Re: Interpretation for RZ/FDP 2004-MV-031, Ivy Development, L.C. (Mazello Cove): Tax  
Map 99-3 ((1)) 3: emergency vehicle turnaround

Re: Request for Interpretation  
RZ 2004-MV-031  
Applicant: Ivy Development, L.C.  
( a.k.a. Mazzello Cove - Fairfax County Subdivision # 6384-SD-01 )

**SITE PLAN REVIEW FORM**

PROJECT NAME/ADDRESS: MAZZELLO COVE

Concept Sketch # 1

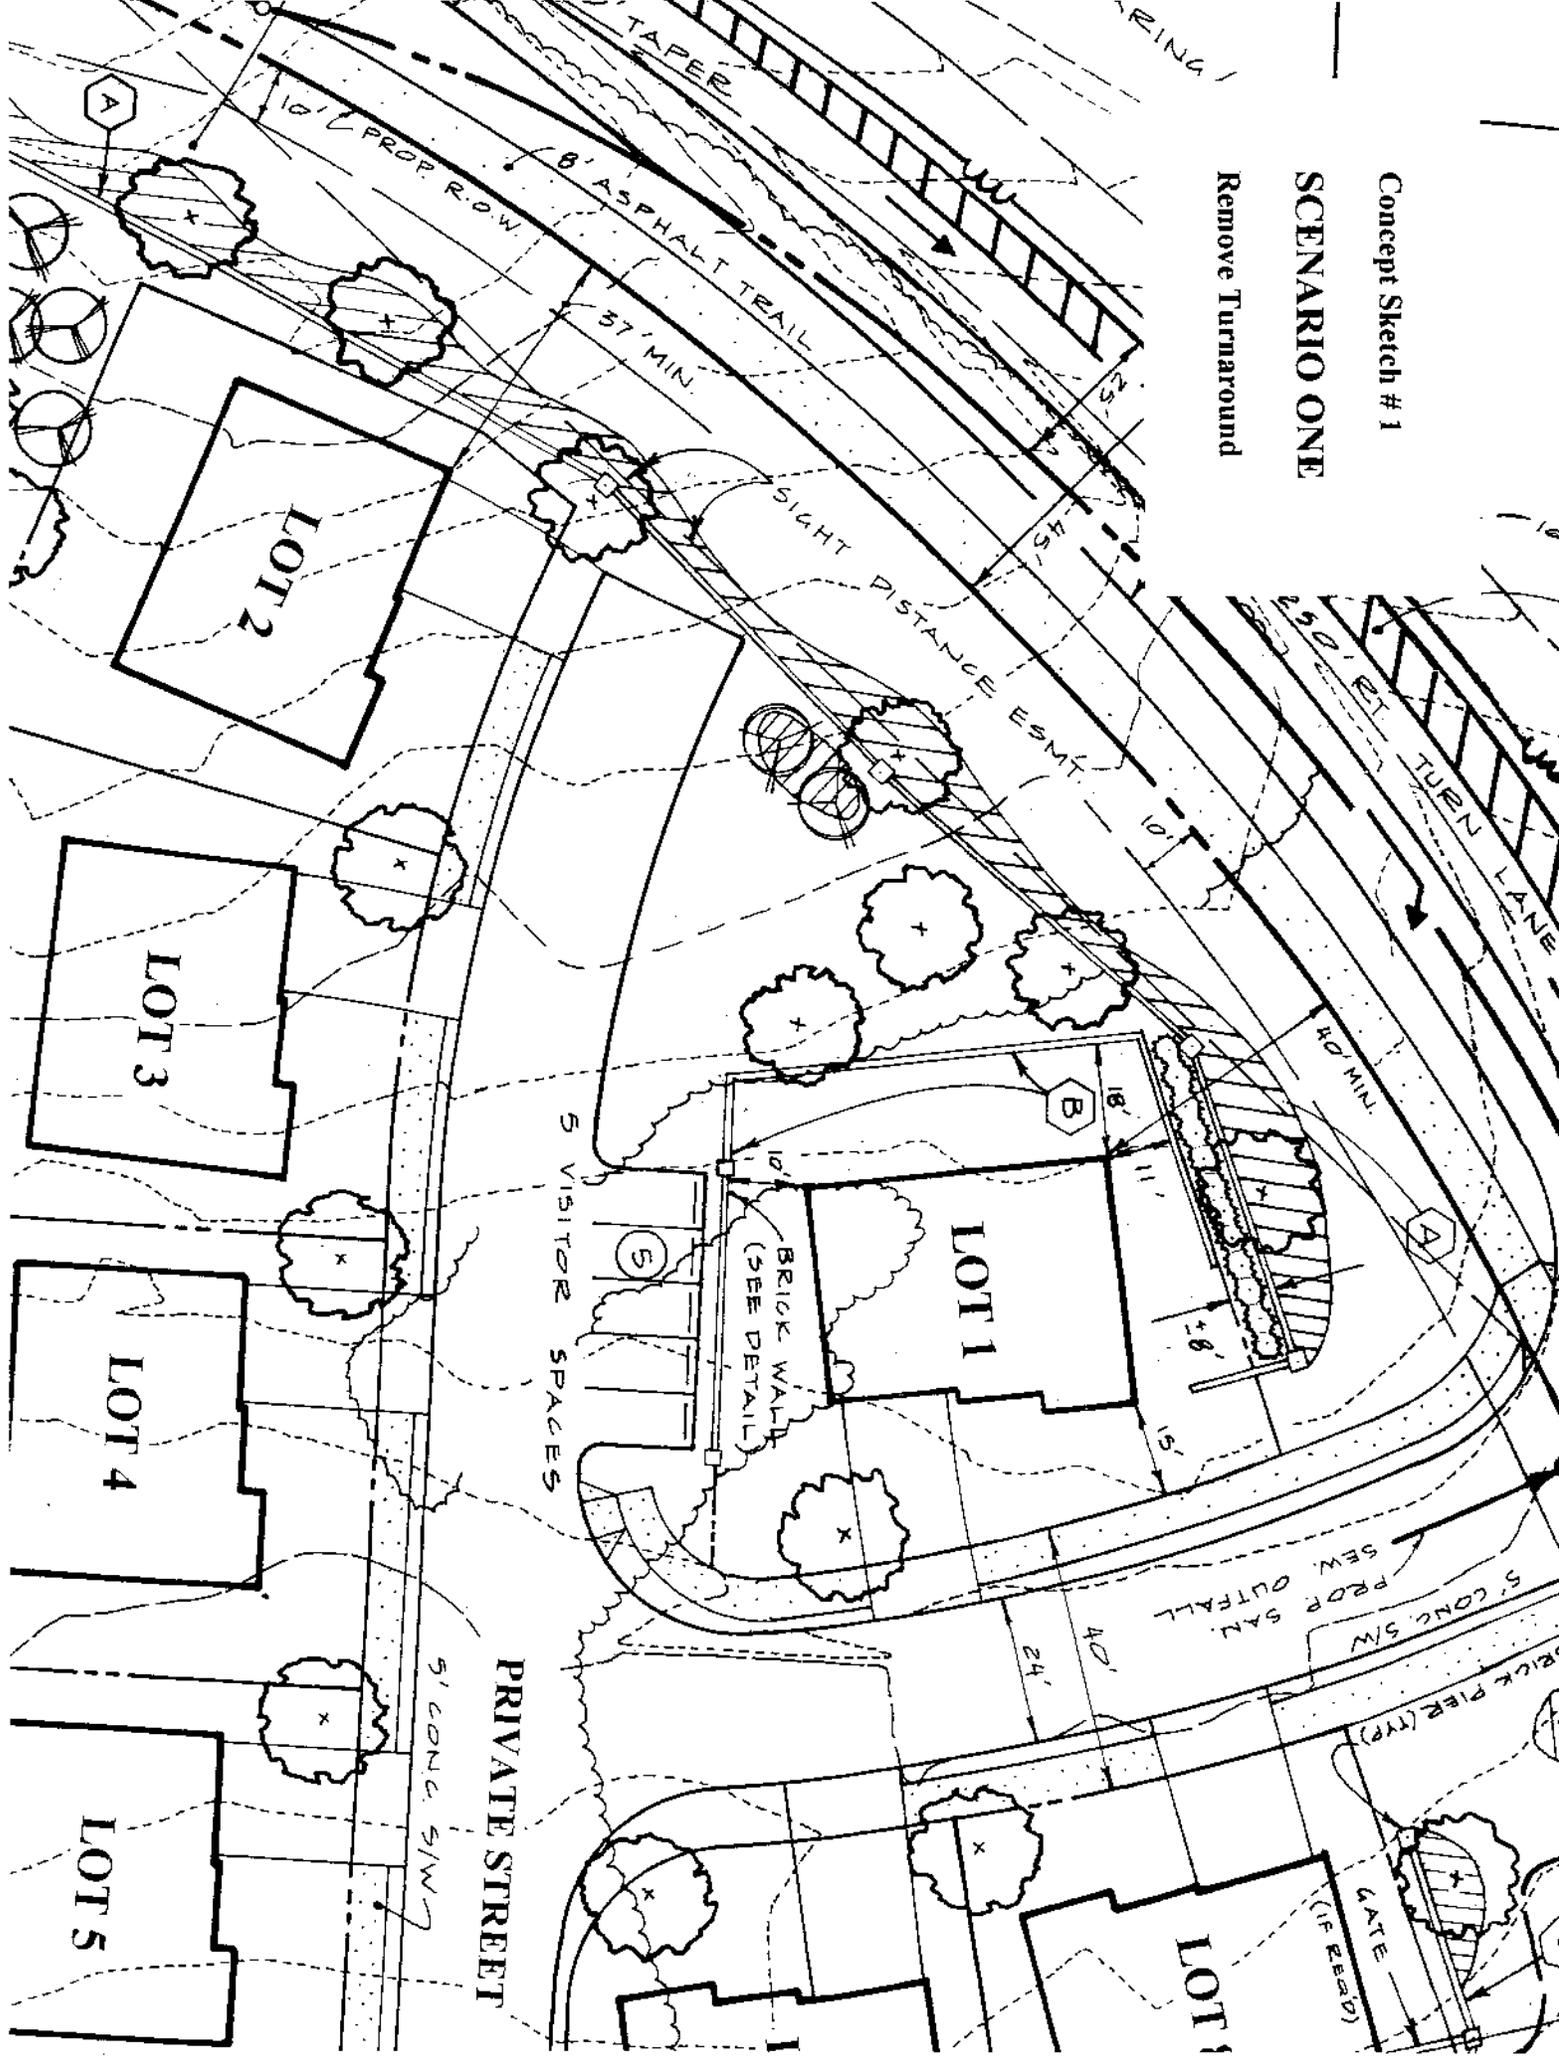
As I understand it, Concept Sketch #2 presents a scenario in which the emergency vehicle turnaround is removed and replaced by the five (5) visitor parking spaces that were approved to be located directly south of Lot 1. With deletion of the vehicle turnaround area, Lot 1 is proposed to be shifted toward the south in order to increase the amount of open space at its rear.

SCENARIO ONE: Remove the emergency vehicle turnaround (See Sketch # 1 attached.)

It is my determination that the proposed removal of the emergency vehicle turnaround and relocation of visitor parking as depicted on Concept Sketch #2 is in substantial conformance with the proffers and development plan provided that additional evergreen plantings are provided between the visitor parking area and the rear lot line of Lot 1 to screen vehicles and headlights.

Concept Sketch # 2

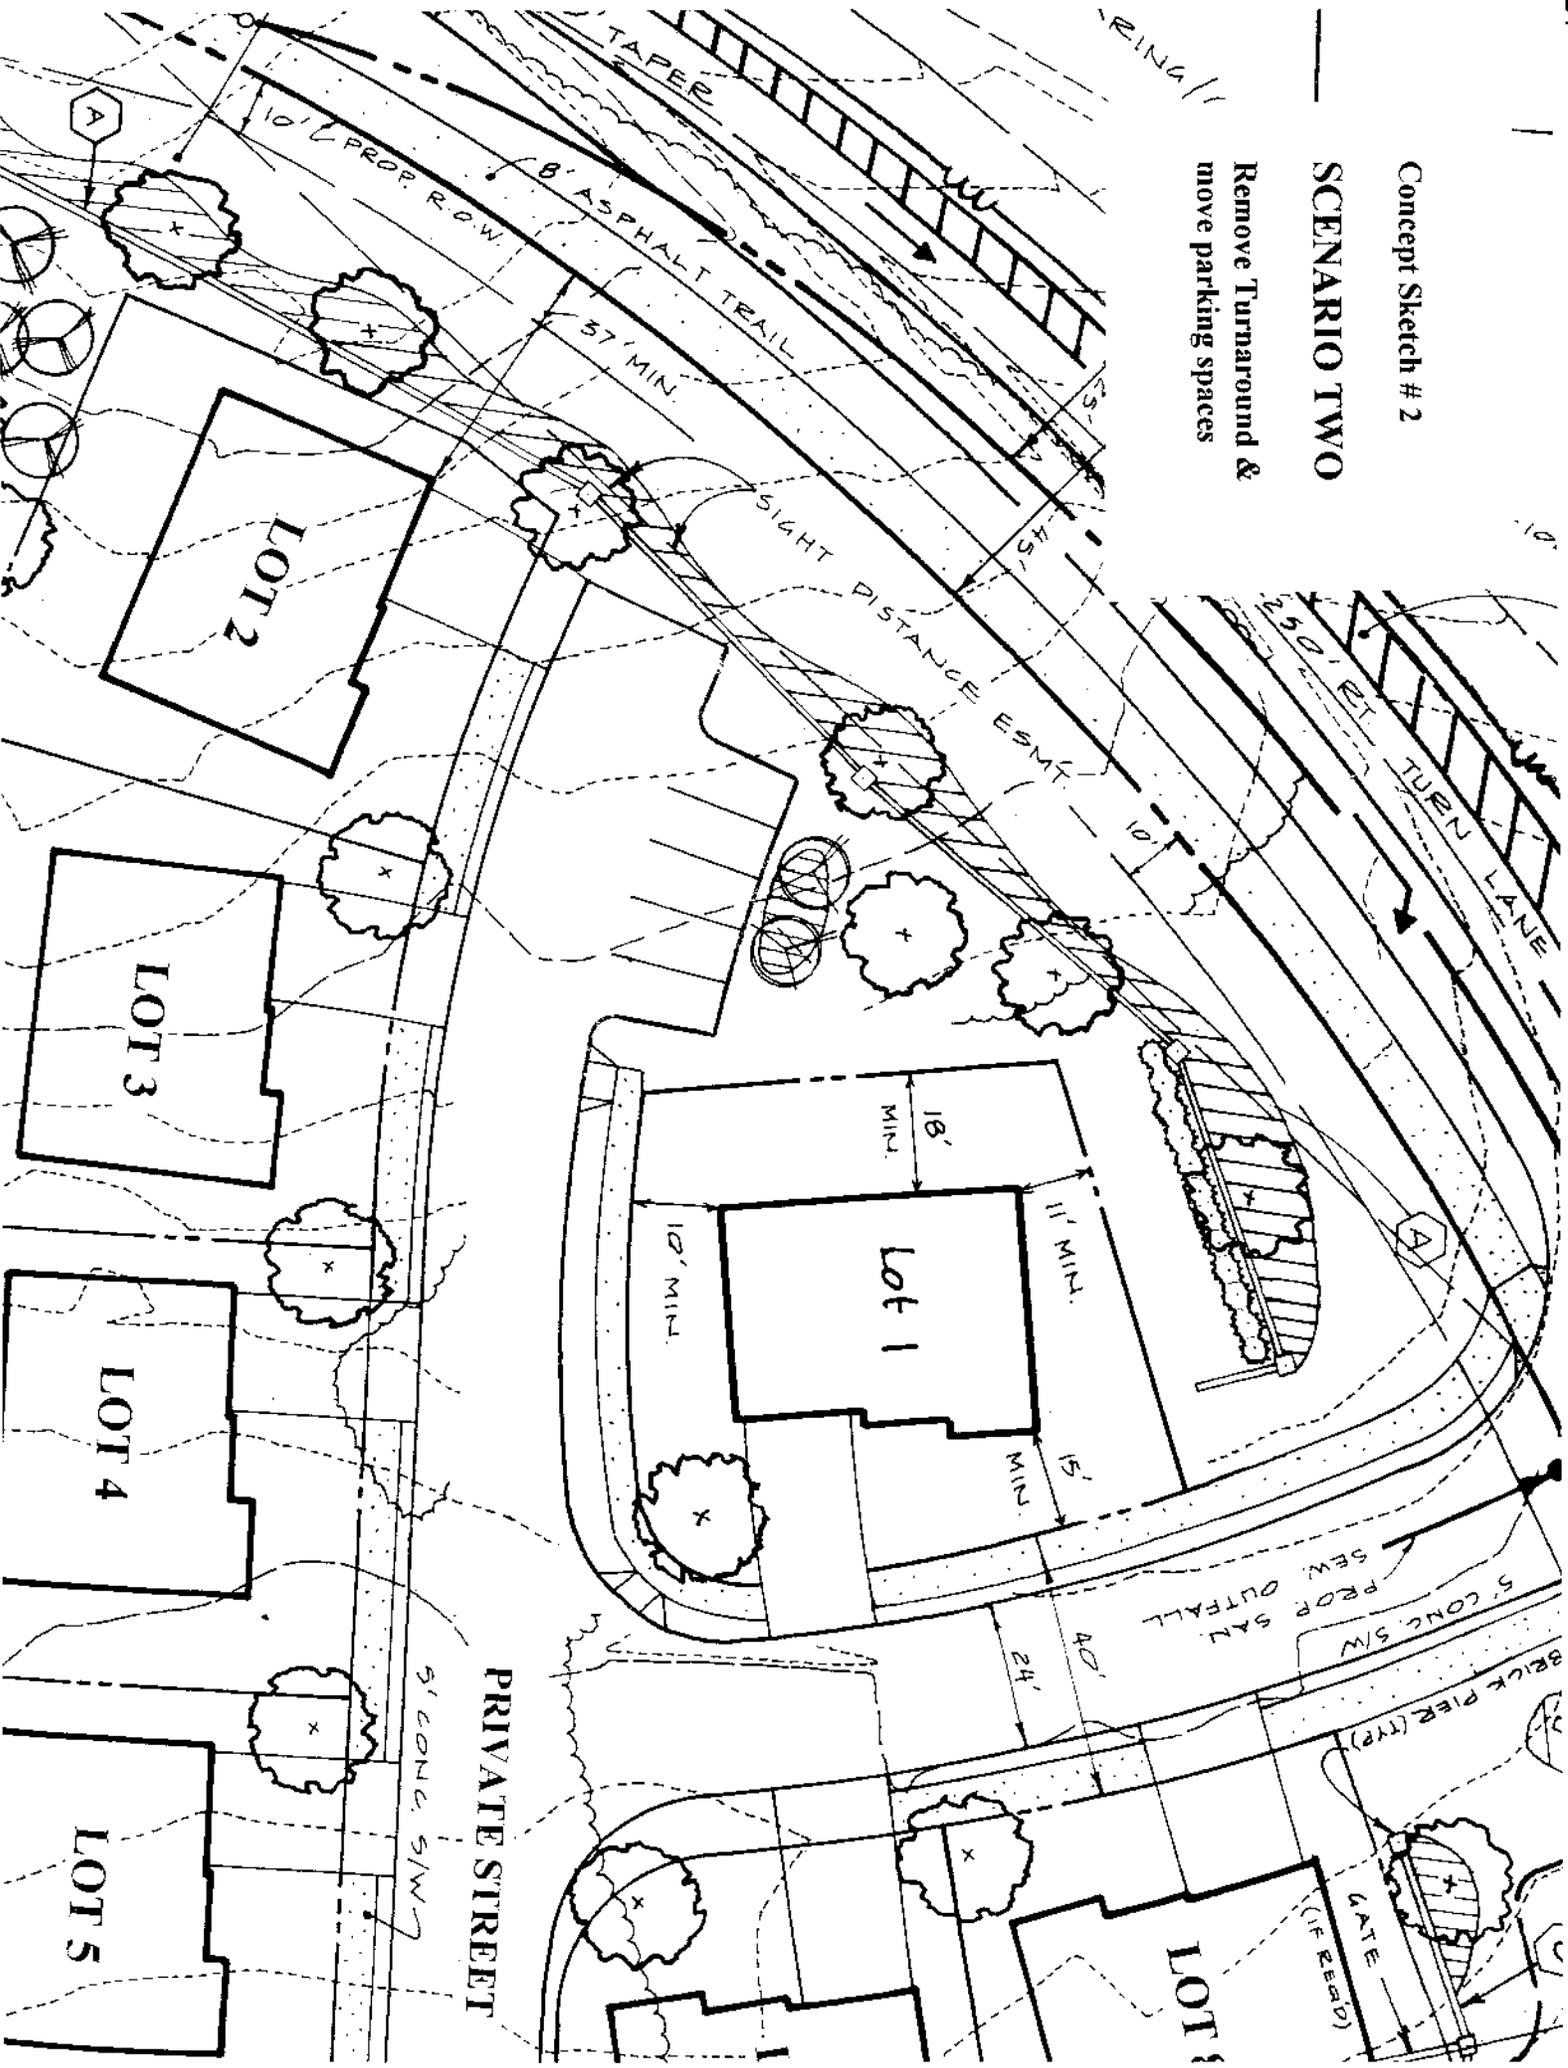
SCENARIO TWO: Remove the emergency vehicle turnaround and slide the guest parking spaces to the west (See Sketch # 2 attached.)

Remove Turnaround & move parking spaces
